## ADDENDUM NO. 02

Date of Issuance: January 24, 2025

Project: **2024 Cypress Falls HS Renovation**  
Cypress-Fairbanks Independent School District

Texas Arcadis Inc.  
Project No.: 202318

1 AREA 'B1' - RCP  
1/8" = 1'-0"

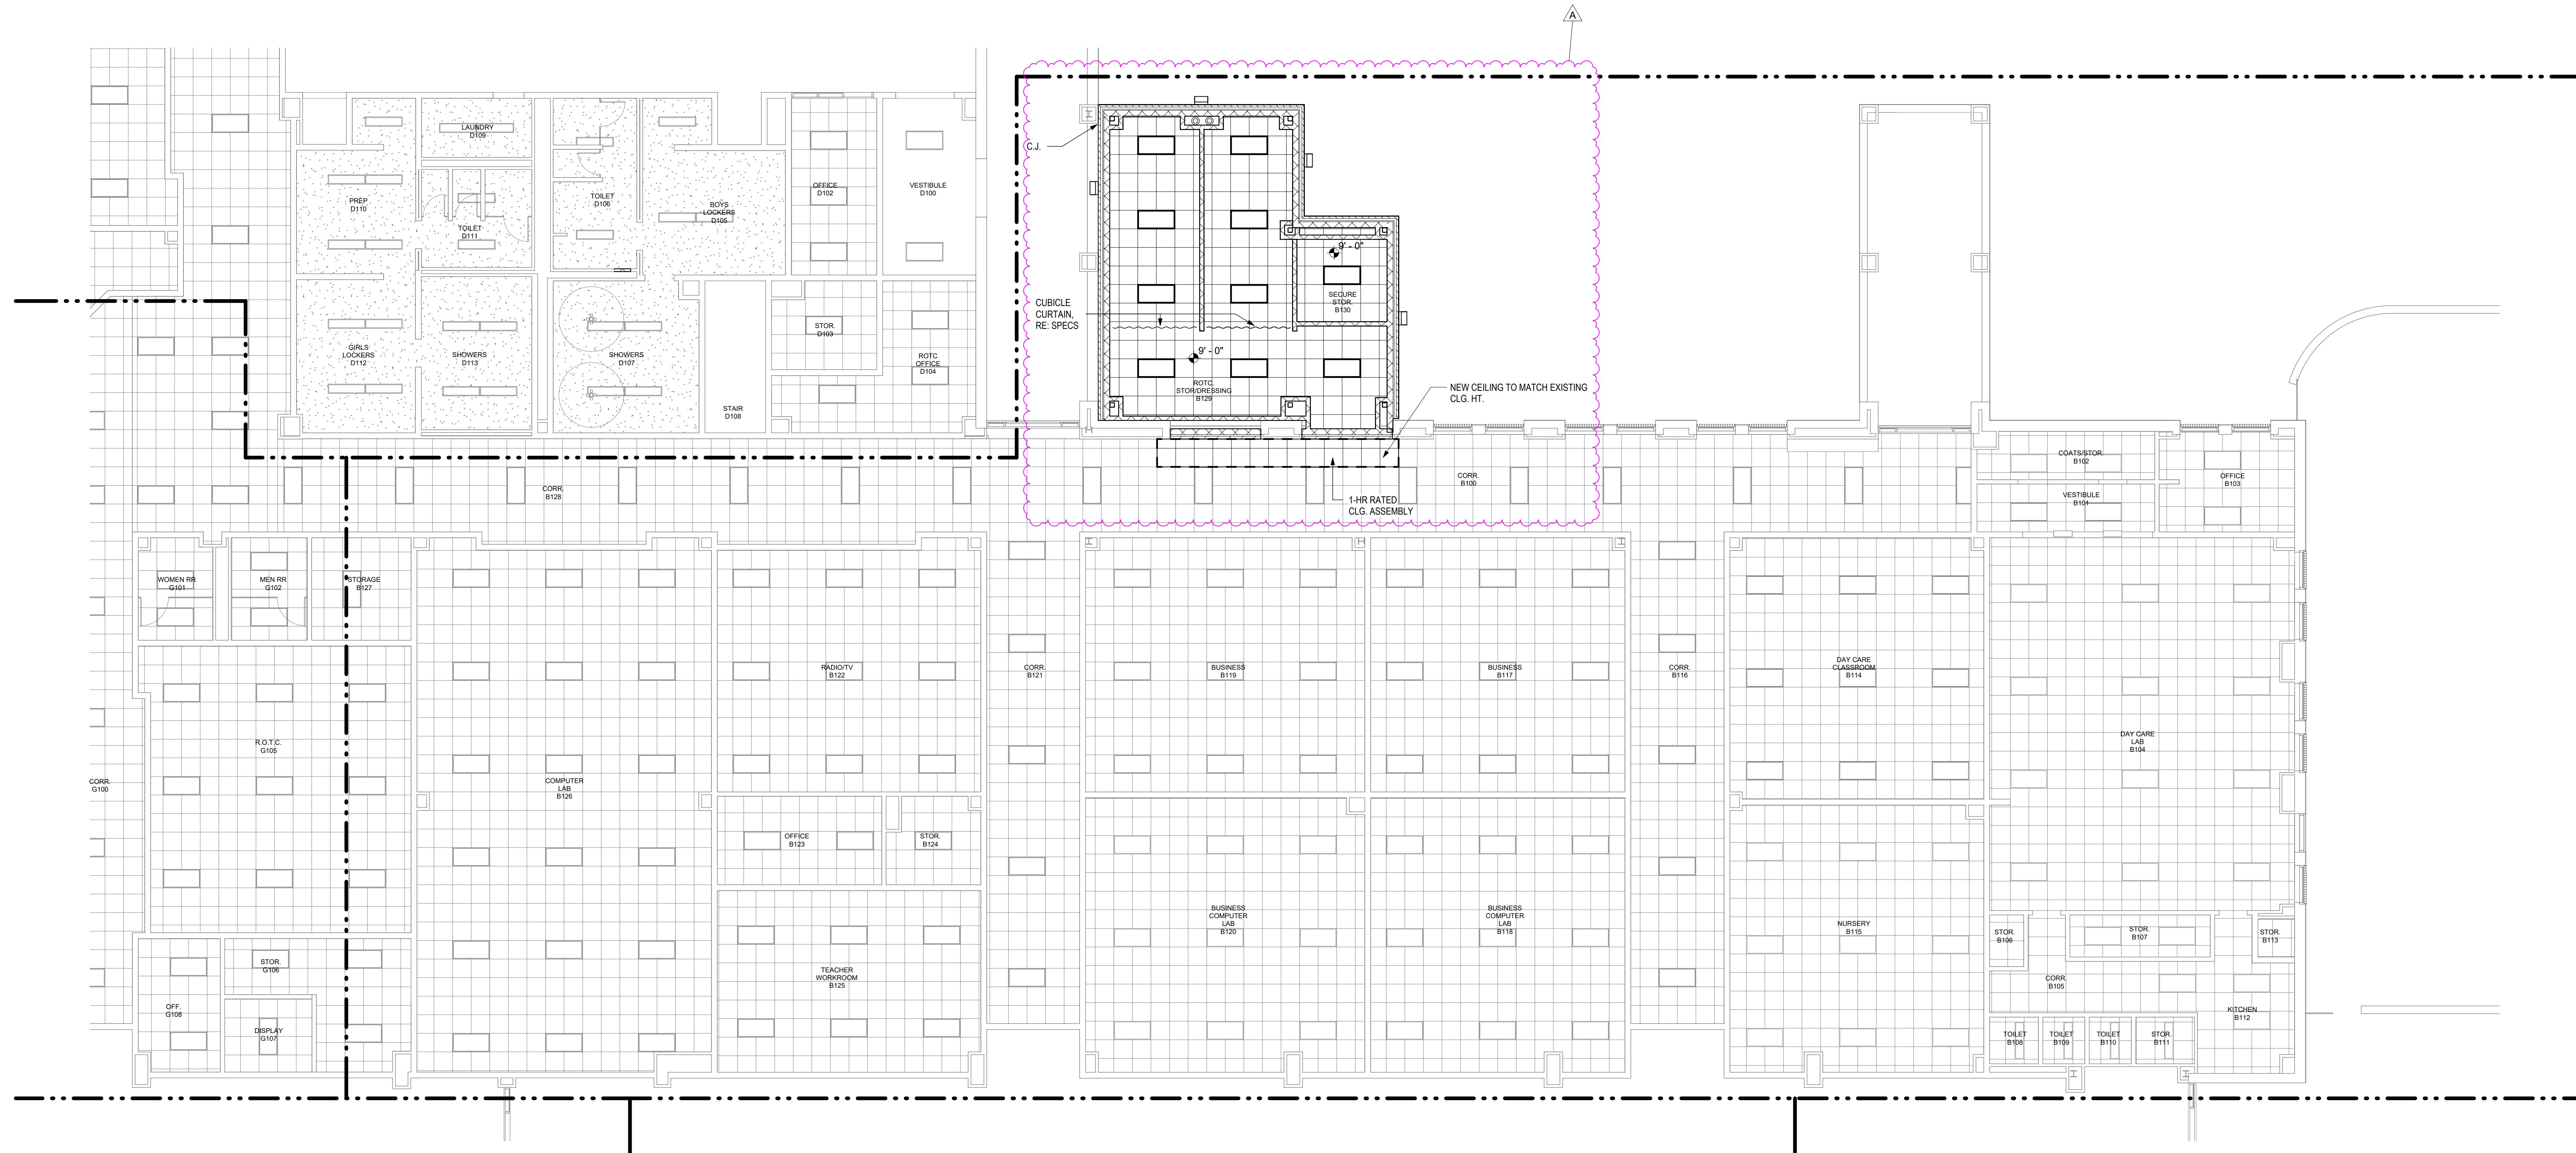
50. Sheet A10.02 - AREA ‘B1’ 1<sup>ST</sup> FLOOR RCP
- a. Section cuts have been removed from sheet.
  - b. Add note, “CUBICLE CURTAIN, RE: SPECS”, pointing at curtains.

- c. Added note, “1-HR RATED CLG. ASSEMBLY” for rated ceilings in corridor.
51. Sheet A10.03 - AREA ‘D1’ 1<sup>ST</sup> FLOOR RCP
- a. Section cuts have been removed from sheet.

**1 AREA 'G1' - RCP**

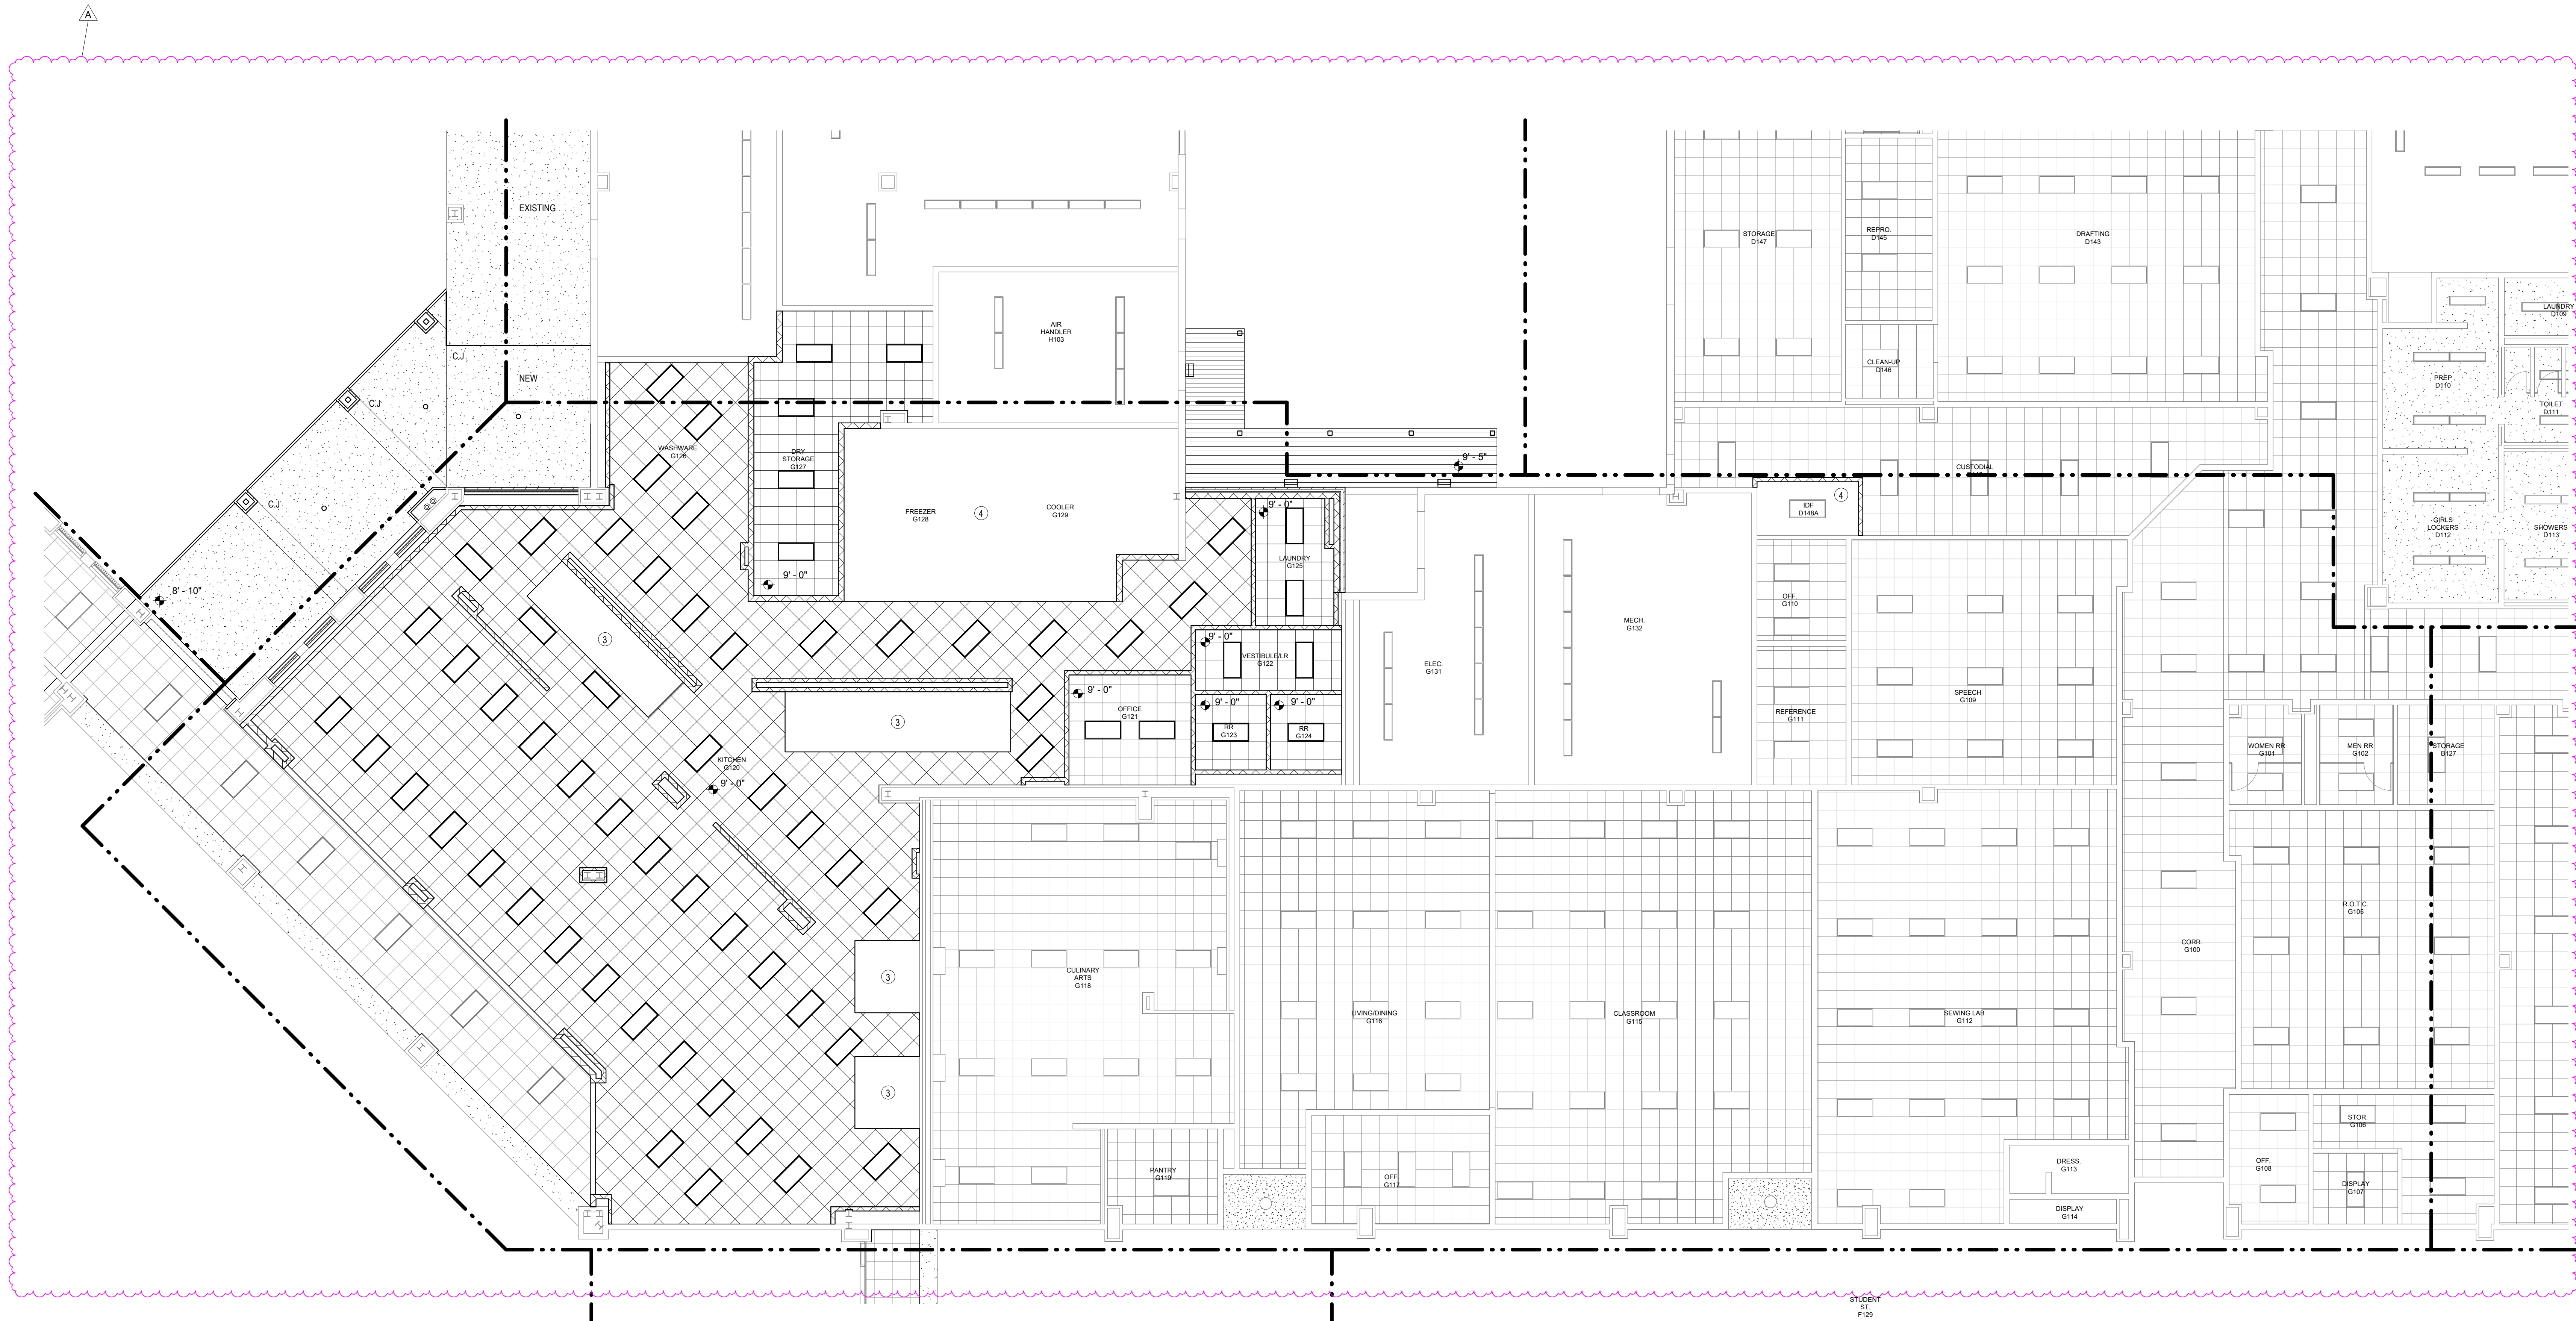
52. Sheet A10.04 - AREA ‘G1’ 1<sup>ST</sup> FLOOR RCP
- a. Section cuts have been removed from sheet.
  - b. Adjusted Ceiling grid around exhaust hoods and new fur out.

- c. Revised Keynote 3 for exhaust hoods.
53. Sheet A10.05 - AREA ‘K1’ 1<sup>ST</sup> FLOOR RCP
- a. Section cuts have been removed from sheet.
  - b. Added note, “1-HR RATED CLG. ASSEMBLY” for rated ceilings in rooms K102 and K111.

**1 AREA 'P1' - RCP**  
1/8" = 1'-0"

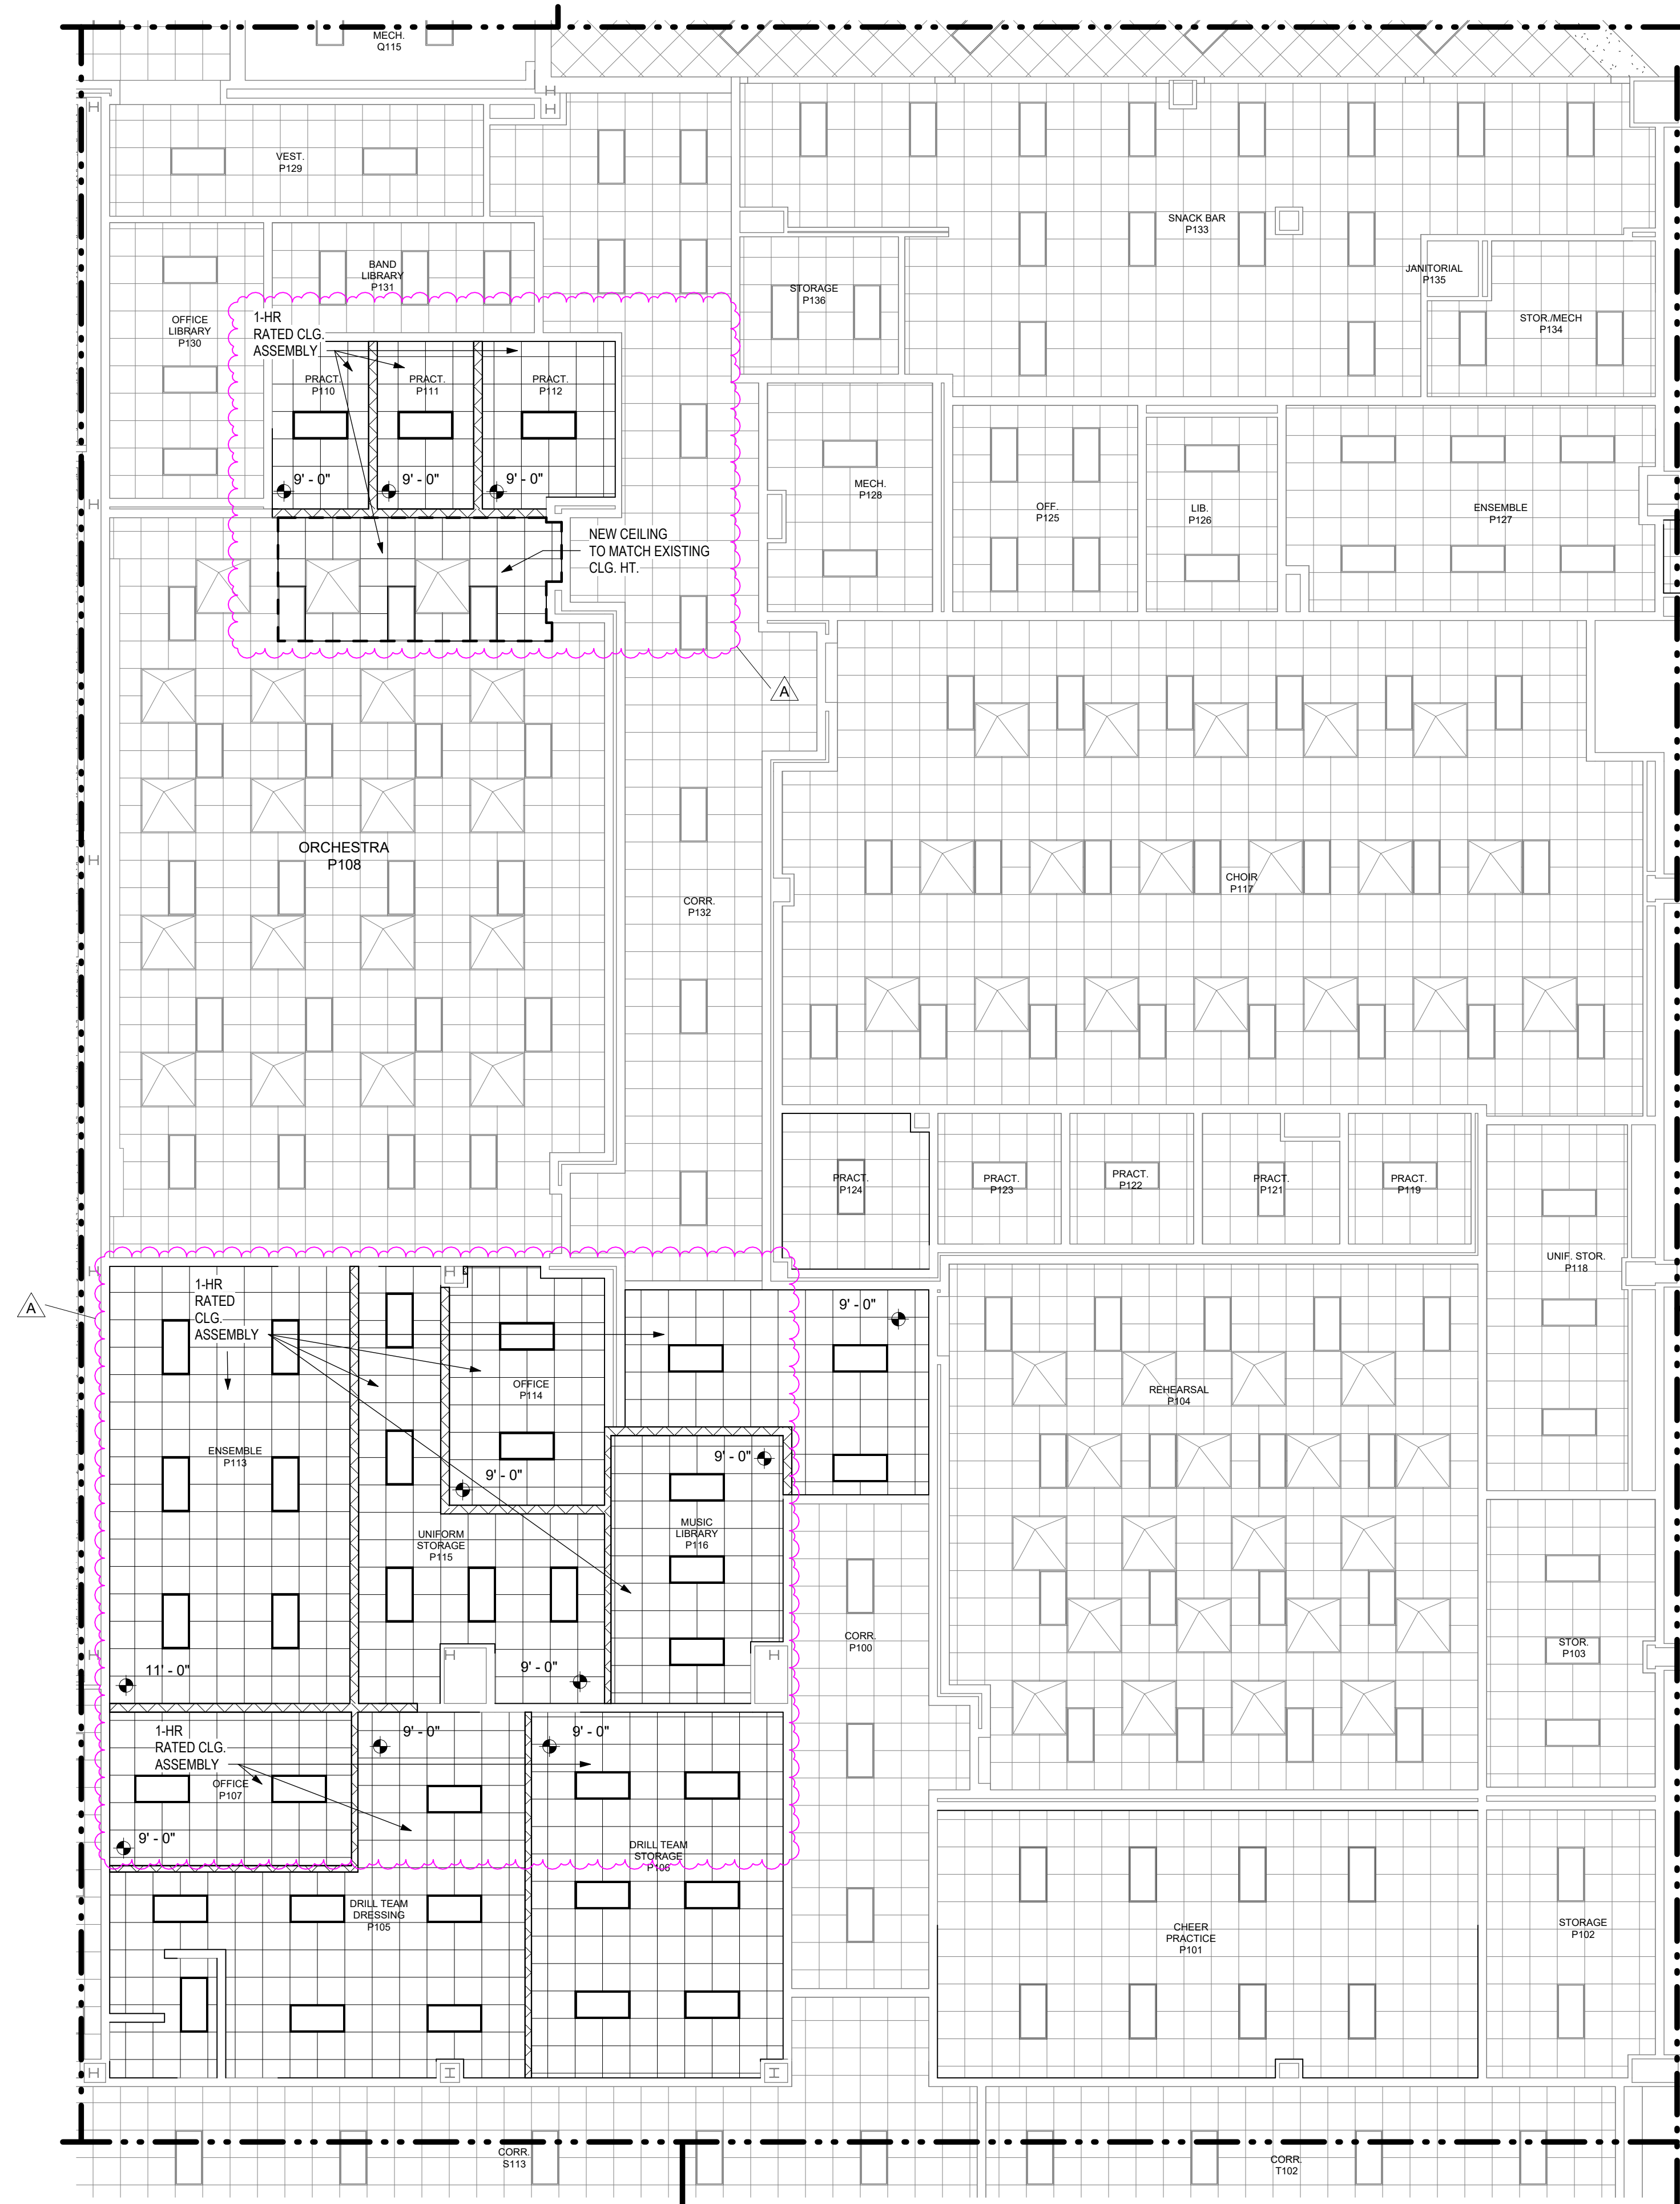
54. Sheet A10.06 - AREA ‘P1’ 1<sup>ST</sup> FLOOR RCP
- a. Added note, “1-HR RATED CLG. ASSEMBLY” for rated ceilings in rooms P105, P106, P107, P108, P110, P111, P112, P113, P114, P115 and P116.
